**Flooding Hazard  
Reevaluation Report**  
Diablo Canyon Power Plant  
**Figure 2-1**  
DCPP Site Location

**Table of Changes to Diablo Canyon Power Plant Units 1 and 2  
 Flood Hazard Reevaluation Report Sections, Tables, and Figures**

**Figure 3-2b**  
 Location and Identification of  
 Commodities on the West of the  
 Turbine Building

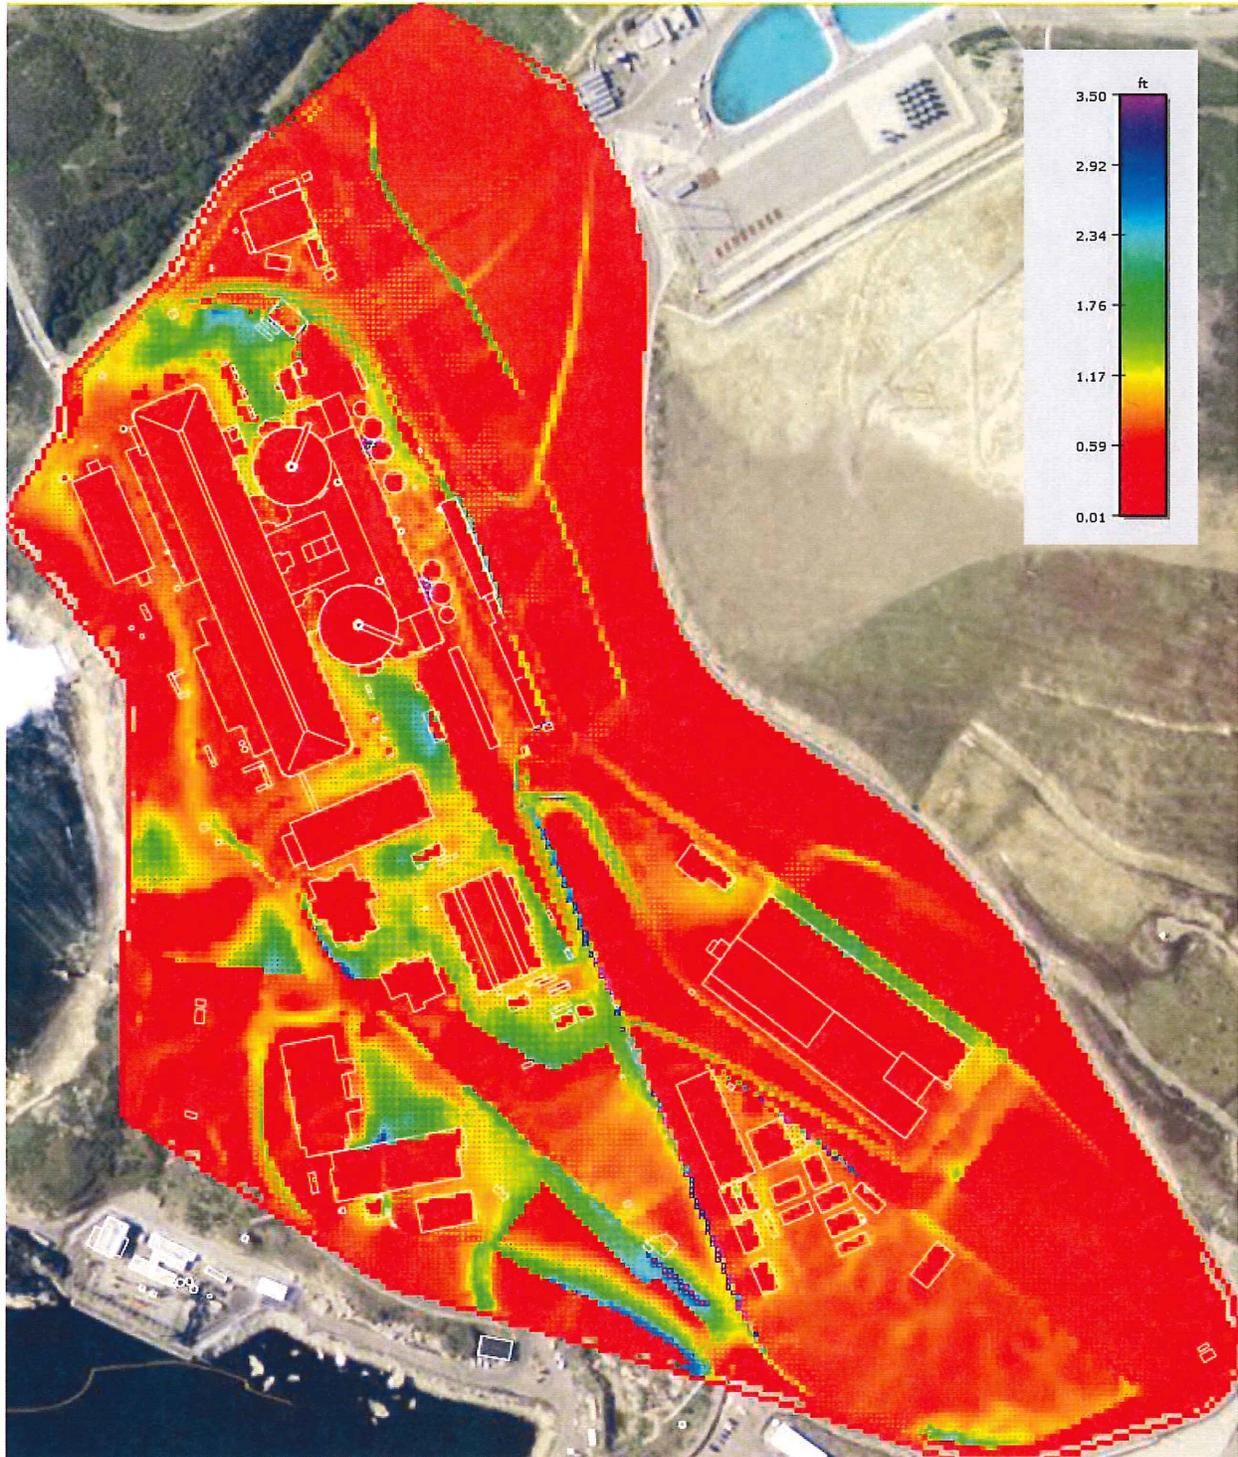
Figure 3-2b	Figure new to Flooding Hazards Reanalysis Report, Revision 1	Figure was added to more clearly show areas and commodities on the West side of the turbine building.	Provides better understanding of LIP inundation results.
Figure 3-3	Included figure	Figure was replaced to reflect revised water depths near the power block structures.	Reflects revised LIP modeling results.
